GUIDE PAGE - REPORT TES-3212

**RESUBMITTAL OF PRIOR APPLICATIONS  
AND SUPPLEMENTS FOR APPROVAL TO  
TRANSPORT THE SENTINEL 25D  
RADIOISOTOPE THERMOELECTRIC GENERATOR  
AS A TYPE B ( ) PACKAGE**

**TES-3212**

**REVISION 2**

FIGURE E-1. SENTINEL 25D GENERATOR/SHIPPING PALLET MOUNTING HARDWARE

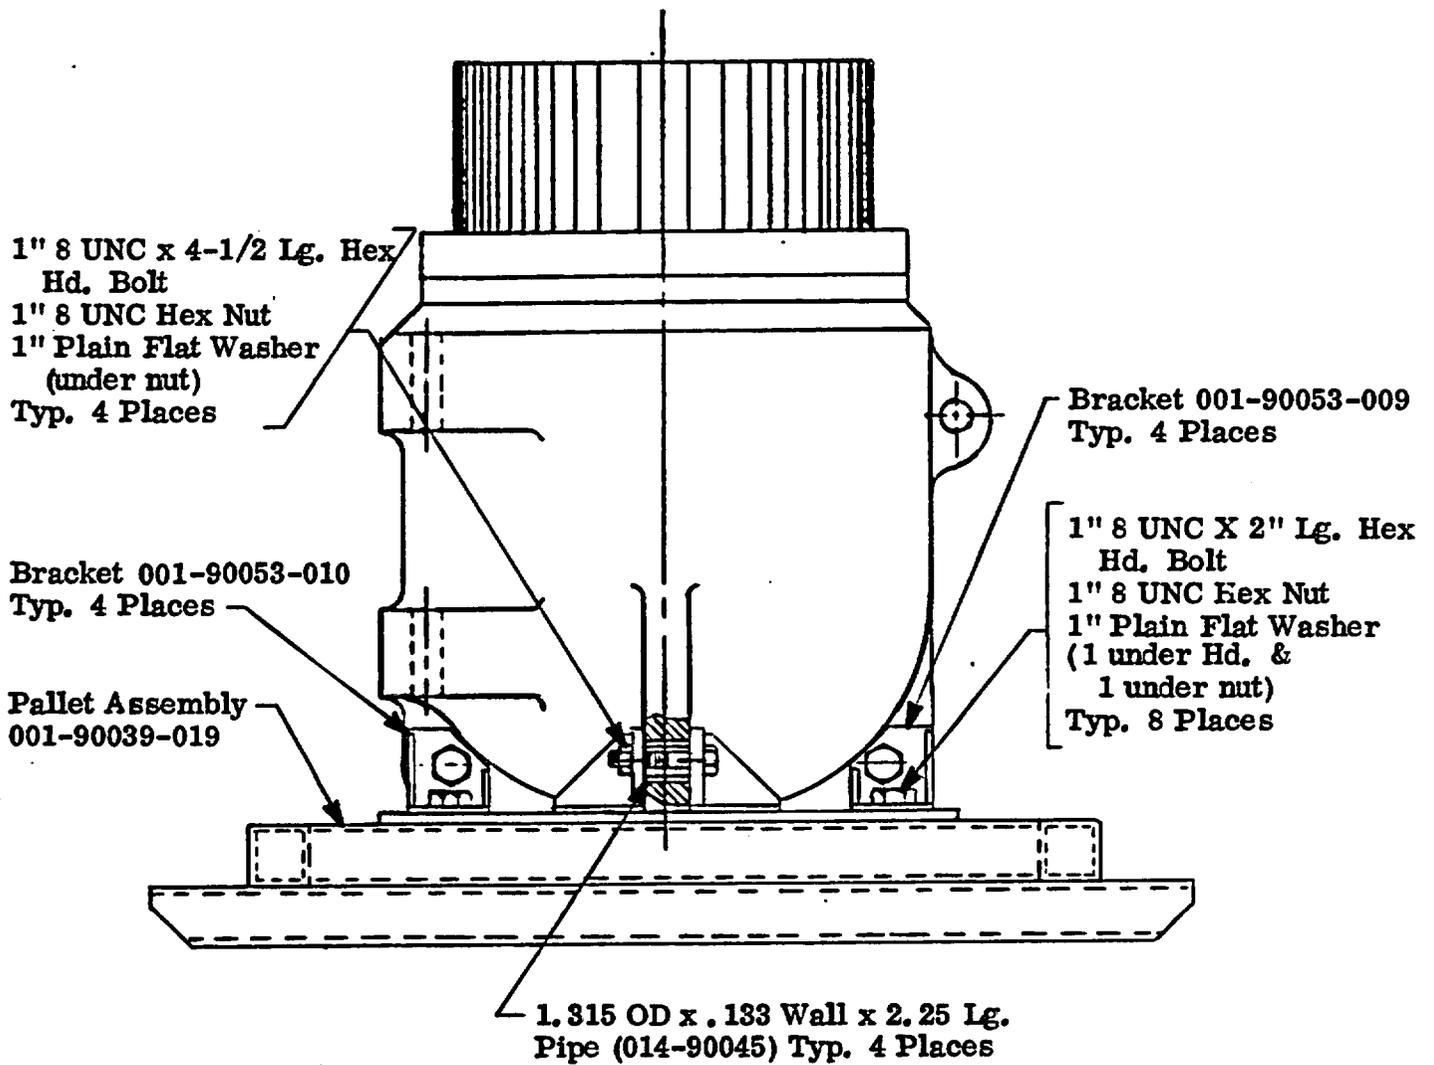
- a. Insure that the finned radiator assembly is bolted to the RTG's lid. (It should not normally ever be removed.)
- b. Insure that the "shorting plug" furnished with the RTG is installed, when the RTG is disconnected from its electrical load.
- c. Insure that the RTG is properly installed on its steel shipping pallet and the attaching hardware shown in Figure E-1 is torqued to 120-130 foot-pounds.

The hardware that attaches the RTG to its shipping pallet (see Figure E-1) should be inspected prior to each shipment for signs of corrosion, structural damage and other forms of deterioration. The hardware must be replaced with new hardware if structural integrity is in doubt.

FIGURE E-2. PALLET TIE-DOWN CONFIGURATION

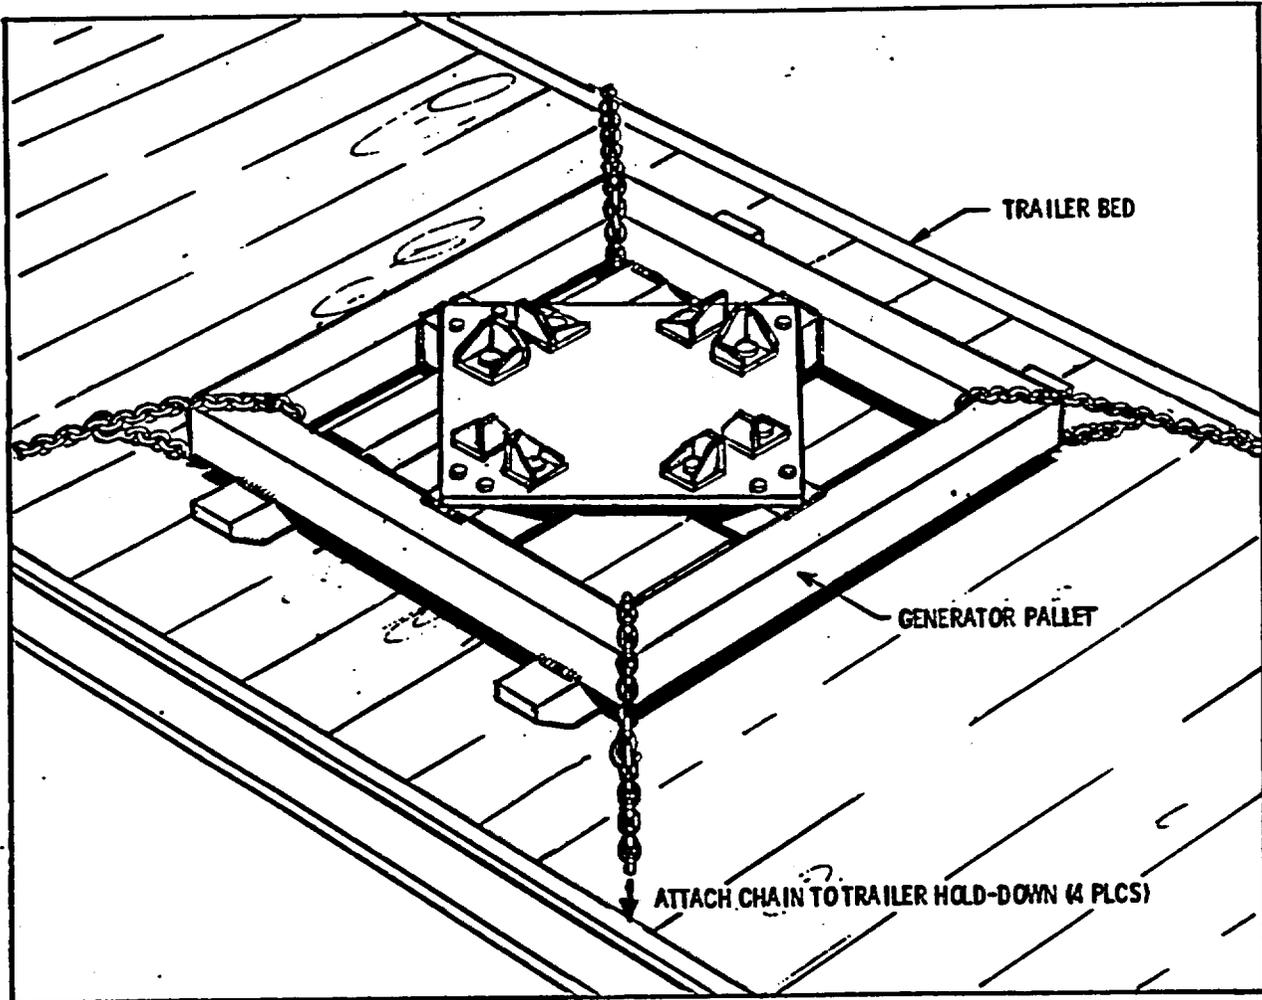
The RTG, when loaded for shipment is to be tied down in a configuration similar to that shown in Figure E-2. In addition, the RTG must not be covered and should be kept at least one foot from bulkheads, other cargo and any other obstructions which might restrict air flow around the generator.
